Thirty-eighth session

Resolution No. 59, “Guidelines for Waterway Signs and Markings”

Amendments to Resolution No. 59

Note by the secretariat

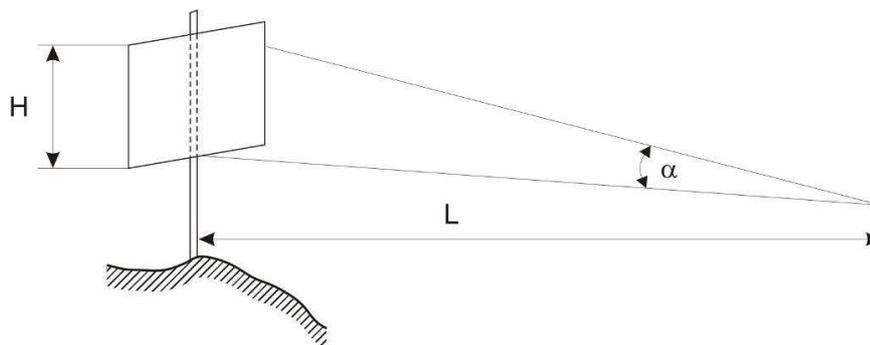
Bank marks, which are used in two-way navigation, shall be oriented as under (a). In some cases (better visibility) angle between the mark and the axis of the fairway can be 10° or less. (Figure 1, sign a).

Bank marks, which are used in one-way navigation, shall be oriented as under (b). In some cases (better visibility) angle between mark and the axis of the fairway cannot be less than 60° (Figure 1, sign c).

22. At the end of paragraph 4.1.7 *add* (Figure 1, sign b)

Figure 2

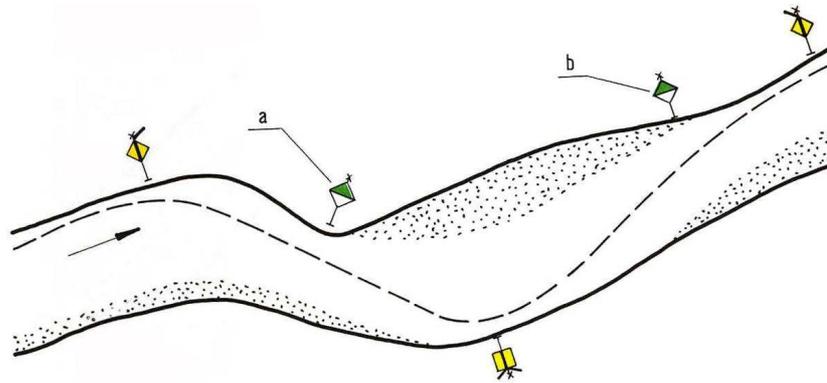
4.2.1.5 If the distance between two neighbouring cross-channel fairway signs is larger than calculated visibility, and when navigation line is passing nearby the bank, the bank lighted sign, which additionally marks the position of the navigation line, is placed between those two neighbouring cross-channel fairway signs (Figure 2, sign a). The bank lighted sign is also placed when the fairway passes near the bank (Figure 2, sign b).

Figure 3

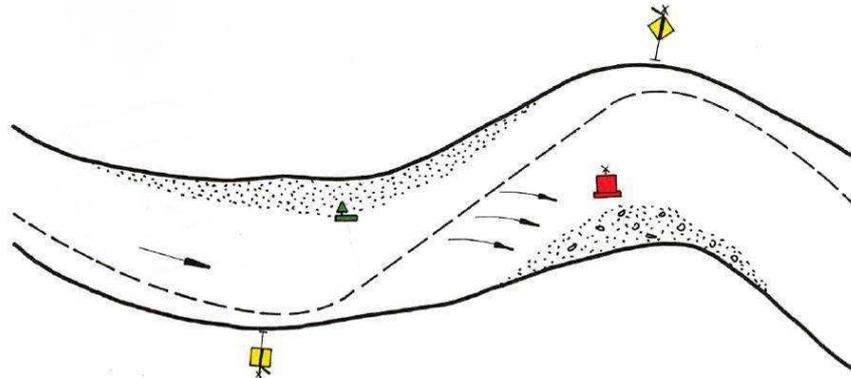
4.2.1.6 In case when the direction of the current makes the angle with fairway, when strong side winds or something alike occurs, fairway can be additionally marked by navigation marks according to the local conditions (Figure 3).

Figure 4

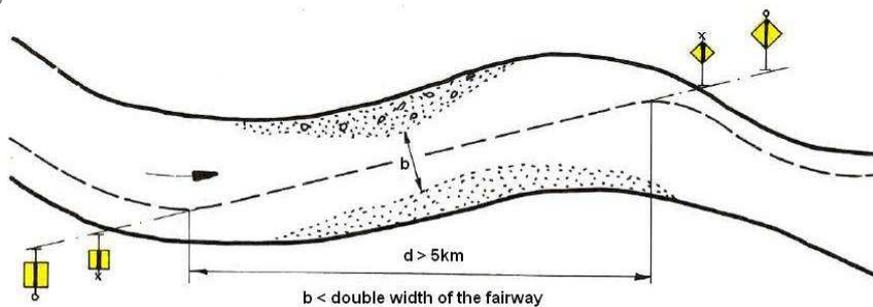
4.2.1.7 If the fairway at longer transitions goes through the river centre or stingingly crosses from one to another bank, then two cross-channel fairway signs on each side of the fairway, which better mark the transition, can be placed as shown on Figure 4.

The advantage is given to two cross-channel fairway signs on each side of the fairway in case of straight-line sections longer than 5 km, where disposable width for navigation is less than double width of the minimum prescribed width of the fairway for particular sector. In that case and when the bank configuration allows so, the cross-channel fairway signs are placed on both margins of transition (Figure 4).

Two cross-channel fairway signs on each side of the fairway are also placed when certain obstacles to navigation or other hazards narrowing the fairway occur.

Figure 5

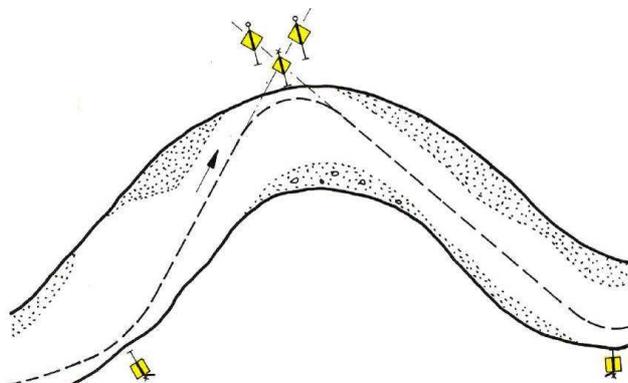
4.2.1.8 On section where the navigation line re-crosses to the opposite bank immediately after transition to the opposite bank, three cross-channel fairway signs (the front should have two boards) are mandatory placed (Figure 5). In that case, lights of the back cross-channel fairway signs should be strictly directed to the fairway axis: one to upstream and other one to downstream.

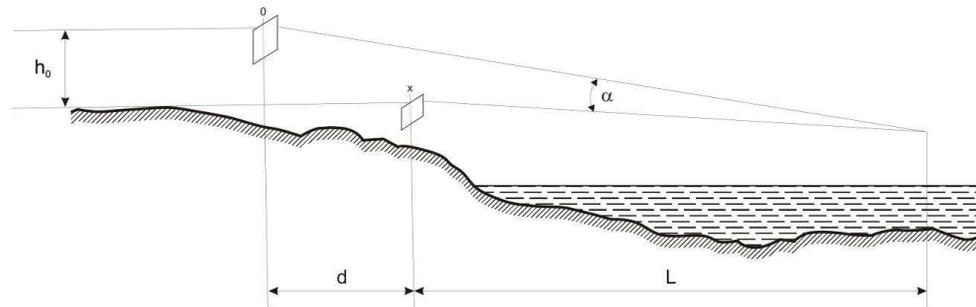
4.1.2.9 Interrelation of the front and back signs at hidden routes shorter than 4 km is presented in Table 3.

Table 3 also assumes that the observer's sight is 5 m above water level, and light of the lower (front) sign is 8 m above the water level.

Value “a” describes accuracy of the route and it's of significance while navigating through a narrow fairway. Accuracy is, in principle, increased by approaching the cross-channel fairway signs.

Due to good recognition of cross-channel fairway signs and their lights by night, the viewing angle α (°) cannot be less than 4'.

Figure 11

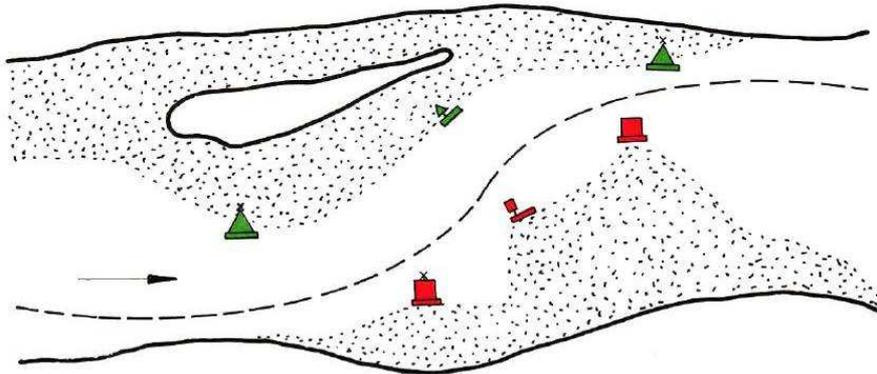
4.3.2 Alternately placed shallow water may also be marked by cross-channel fairway signs, with sufficient disposable width for navigation in which vessels are passing in straight-line (Figure 8).

Figure 12

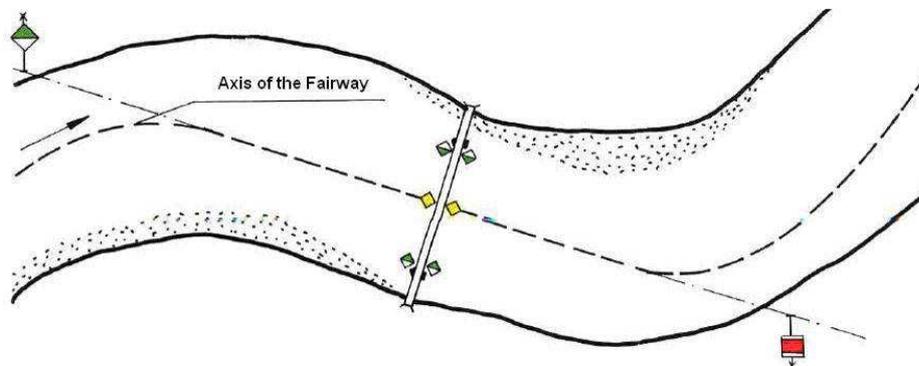
(a) If bridge is in inflexion, the direction of vessels passing through the bridge passages may be marked by signs on the water (B.1, B.2 Annex 8 to CEVNI) (Figure 12).

Figure 13

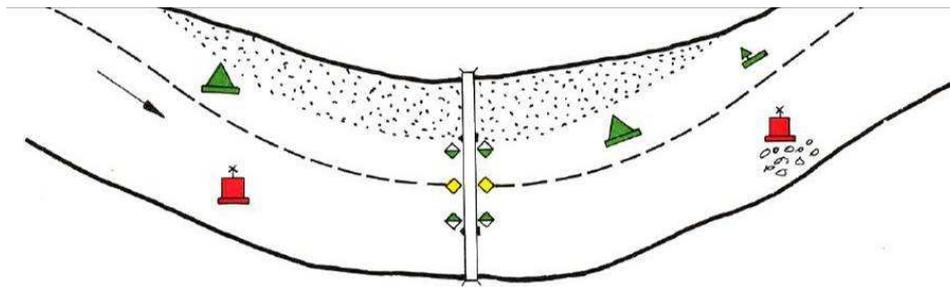
(b) If, due to larger curvature of the fairway or some other reasons, marking by the aforementioned signs is not possible, signs and signals on the water (buoys, etc.), placed in order to follow the current, may be used (Figure 13).

Figure 14

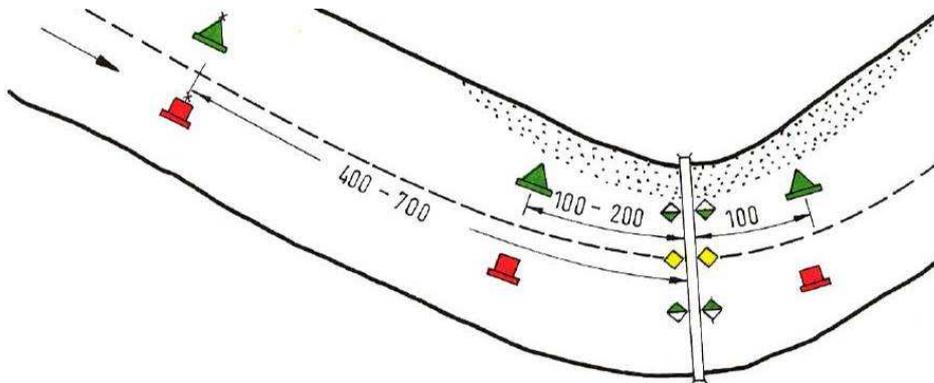
(c) If the bridge is positioned on the section where the current makes an angle with the fairway, marking may be done by two pairs of buoys upstream of the bridge. Pair of buoys closer to the bridge are placed on 100 m – 200 m distance upstream of bridge, and second pair of 400 m – 700 m upstream of bridge. Buoys more distant from the bridge are placed in order to follow the river flow jointly with the closer pair of buoys. Another pair of buoys may be placed downstream of bridge on 100 m distance from the bridge (Figure 14).
